DEVELOPMENT and PLANNING SERVICES COMMITTEE

8:00 a.m.

SUBJECT: Development Permit Application No. DP-414 (Residential)

Civic: 2081 - 11 Avenue NE

SHEET TITLE:
PROPOSED
SITE PLAN &
RECONCILIATION

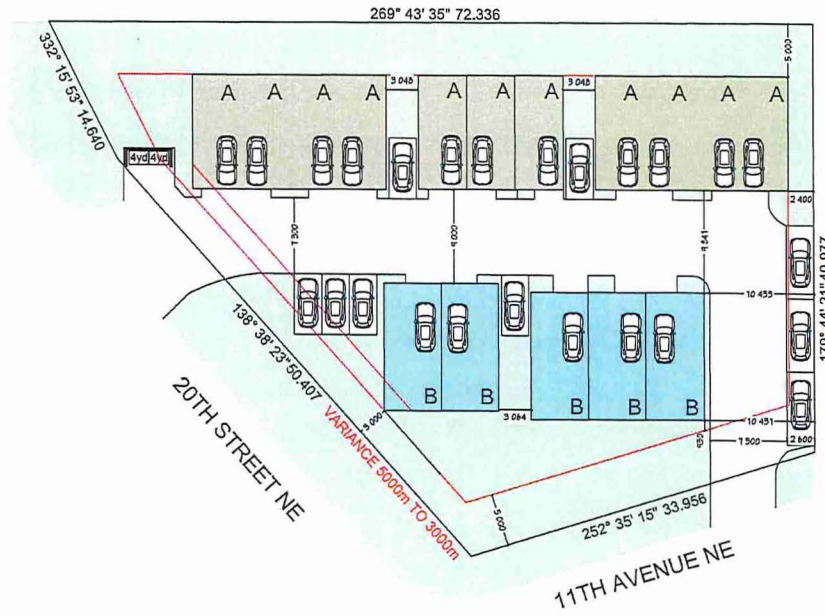
There is one variance requested associated with the proposal, to reduce the exterior side parcel line setback from 5 m to 3 m along a portion of 20 Street NE, affecting the south-west corner of the western-most 4-plex building and the western-most duplex building.

A variance is requested to reduce the exterior side parcel line setback from 5 m to 3 m along two portions of 20 Street NE to accommodate the south-west corner of one of the 4-plex buildings and one of the duplex buildings. Staff view this request as reasonable and minor, taking into account the wide boulevard at this location, the adjacent street orientation, and what would appear to be a minor potential for impact on adjacent developments to the north and east.

The subject property is a corner parcel with dual 2-way vehicle access proposed via 11 Avenue NE to the south and from 20 Street NE to the west. This should provide an option during times of busier traffic, such as school drop-off/pick-up. The 26 parking spaces as proposed exceeds the 20 required (1.25 parking spaces per dwelling unit) as specified by the Zoning Bylaw. Given the lack of street parking at this location, staff feels this additional parking proposed will be well-used and appreciate its inclusion.

1. Section 10.9.4 – reduce the west exterior side parcel line setback from 5.0 metres to 3.0 metres;
